ADDENDUM NUMBER 3

JOB #01613.00

Sanitary Sewer for Northwest High School

NORTHWEST HIGH SCHOOL

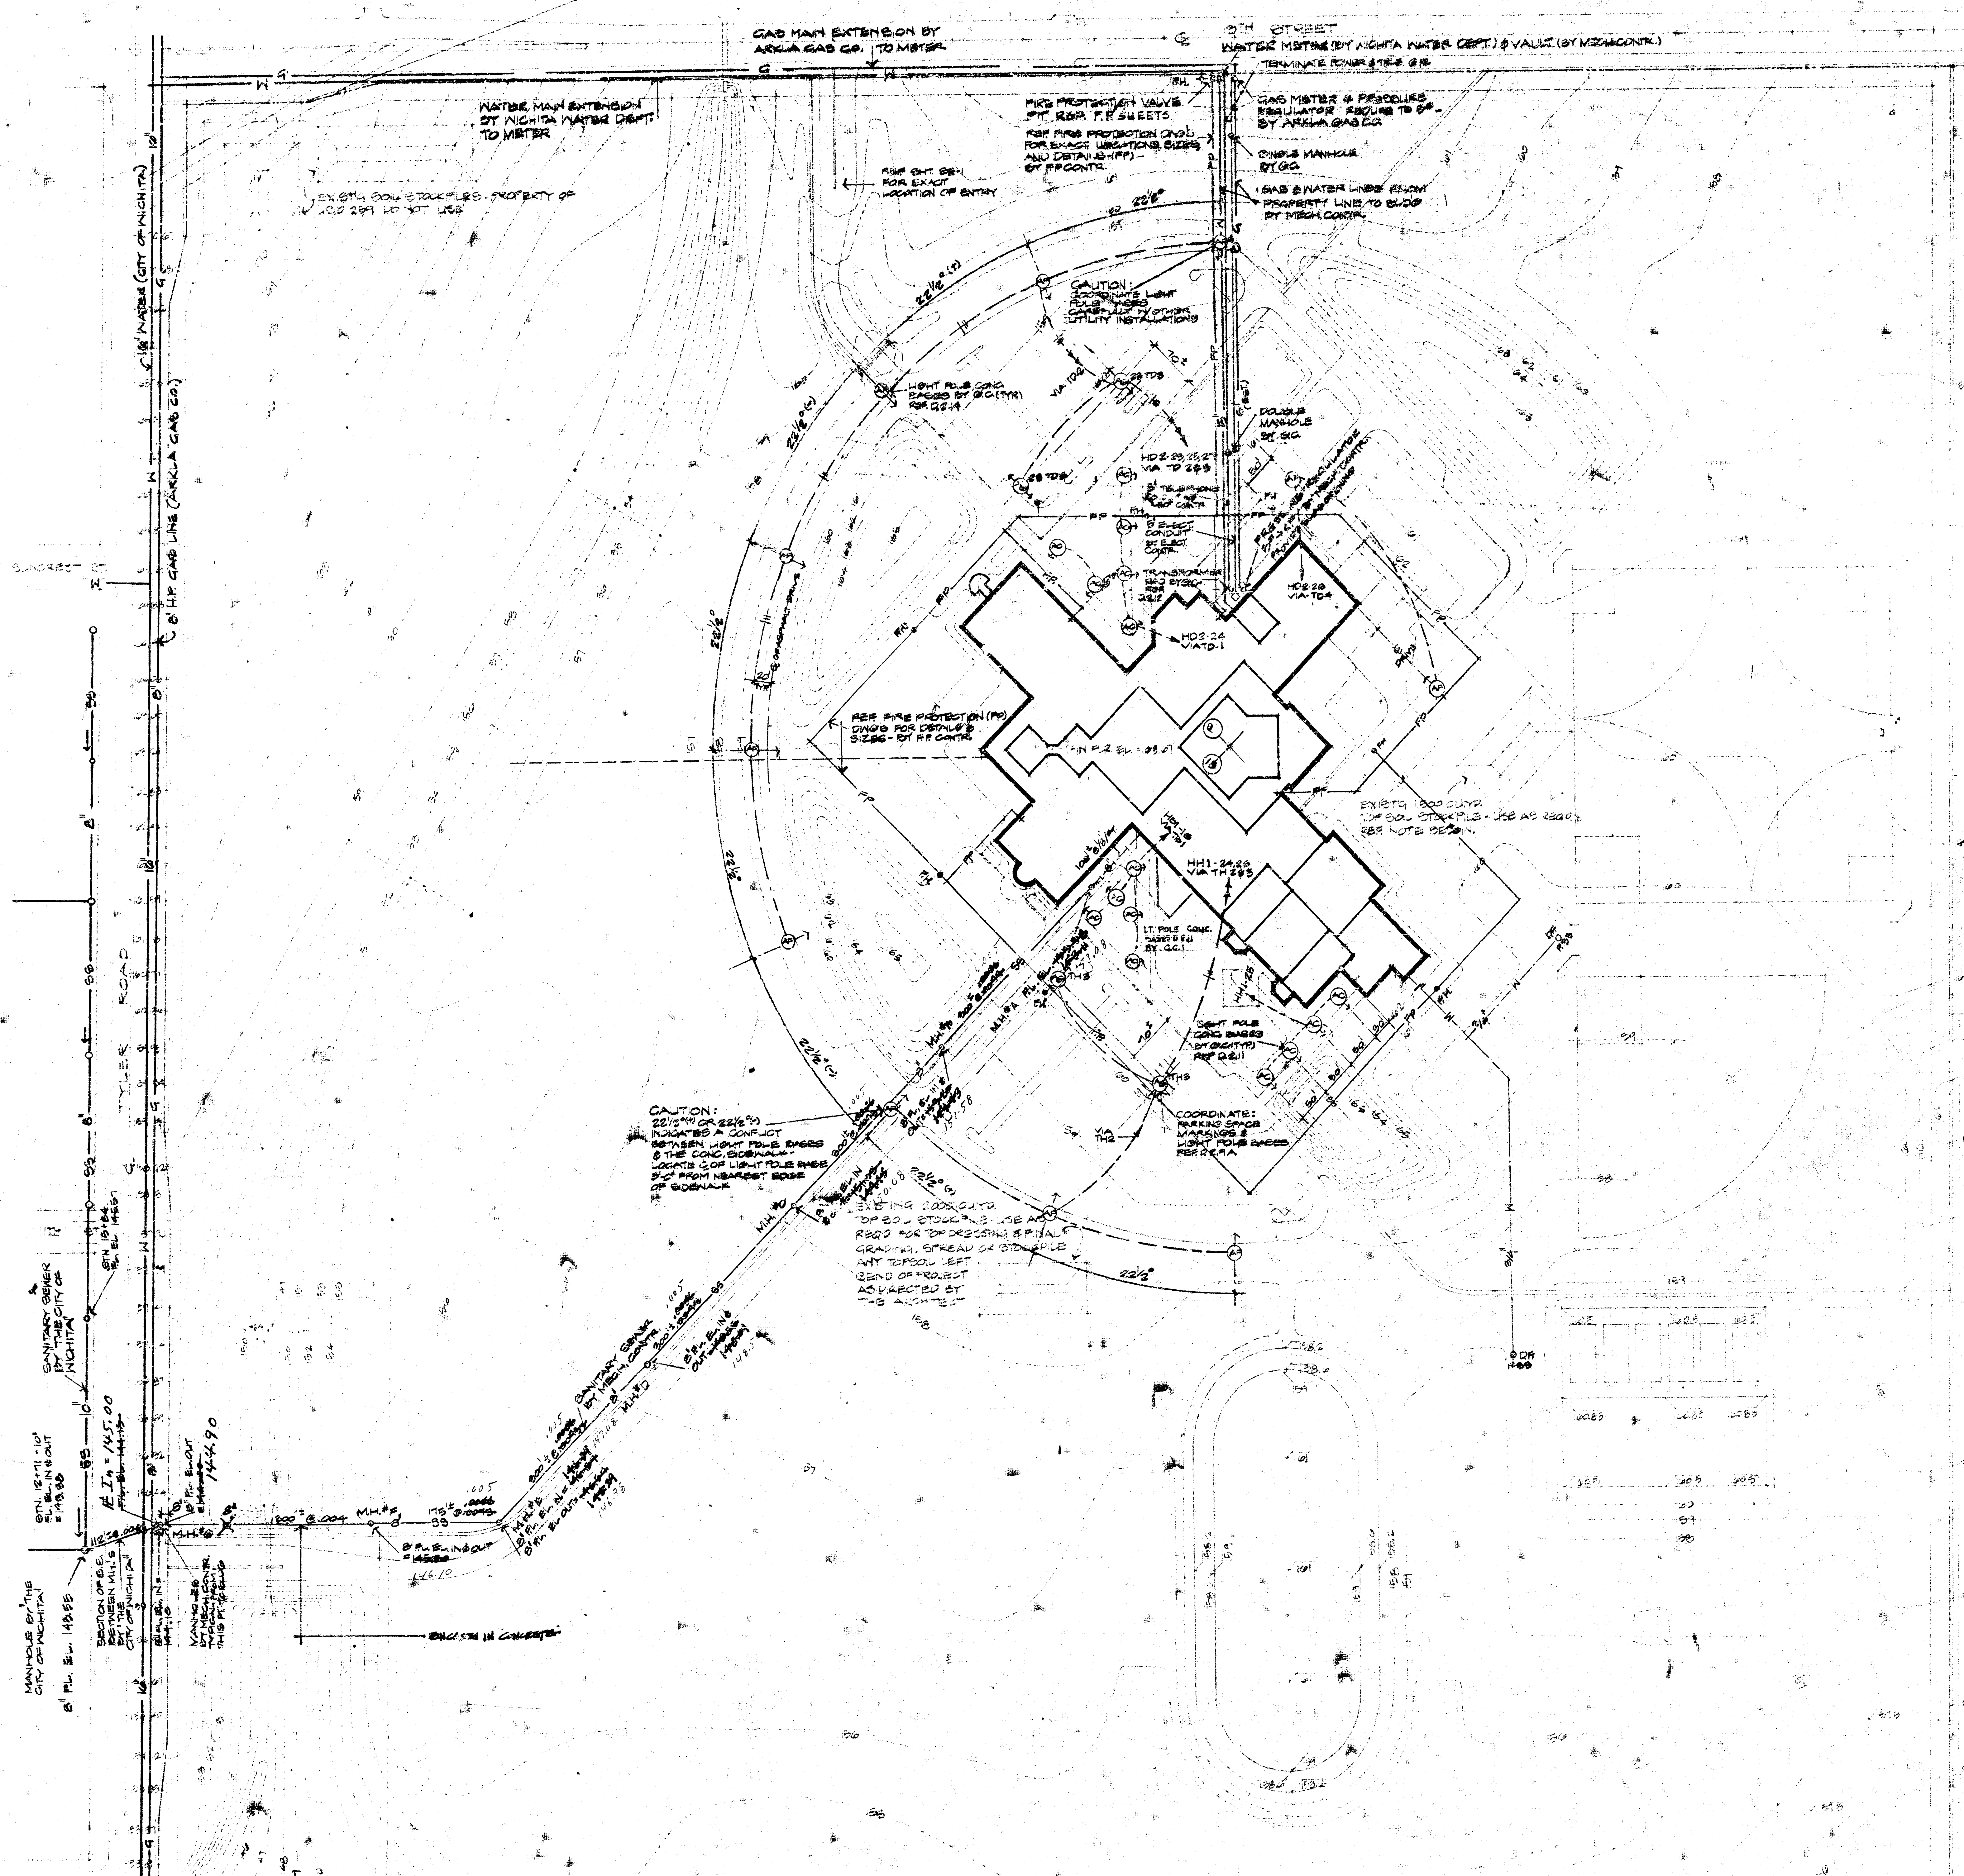
ITEM #3-M37:
DRAWING SHEET SE-3 - REVISE ALL REFERENCES TO ENGINEERED SANITARY SEWER SLOPE OF .0073 TO READ .0056.

ITEM #3-M38:
DRAWING SHEET SE-3 - REVISE CERTAIN ENGINEERED SANITARY SEWER FLOW LINE DESIGNATIONS AS HEREIN INDICATED:
MANHOLE #A FLOW LINE ELEVATION IN AND OUT = 153.11
MANHOLE #B FLOW LINE ELEVATION IN AND OUT = 151.43
MANHOLE #C FLOW LINE ELEVATION IN AND OUT = 149.75
MANHOLE #D FLOW LINE ELEVATION IN AND OUT = 148.07
MANHOLE #E FLOW LINE ELEVATION IN = 146.39
MANHOLE #E FLOW LINE ELEVATION OUT = 146.29

ITEM #3-M39:
DRAWING SHEET SE-3 - DELETE FLOW LINE ELEVATION REFERENCE AT MANHOLE #G READING; "F.L. EL. 144.15".

ITEM #3-M64:
DRAWING SHEET SE-3 - RE: APPROXIMATELY 30' FT. OF ENGINEERED SANITARY SEWER PIPING BETWEEN MANHOLES NO. 'F' AND 'G':
A) DELETE SIZE DESIGNATION OF 10" AND INSERT 8".
B) THIS SECTION OF PIPING SHALL BE ENCASED IN CONCRETE; CONCRETE SHALL EXTEND A MINIMUM OF 6" BEYOND PIPE IN ALL DIRECTIONS.
